Working Party on the Transport of Perishable Foodstuffs

Report of the Working Party on the Transport of Perishable Foodstuffs on its seventy-second session

held in Geneva from 4-7 October 2016

"Figure 6: Estimated values for a body with a rounded roof

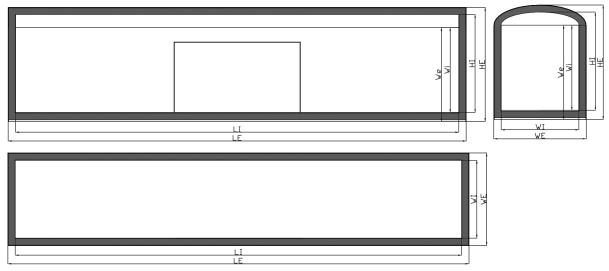
$\frac{PI}{2}$ is the length of the inner arc of the rounded roof, in m;

HE is the mean outer height of the body on a central axis, in m;

$\frac{PE}{2}$ is the length of the outer arc of the rounded roof, in m;

7. Insert the following drawing in the ATP Handbook:
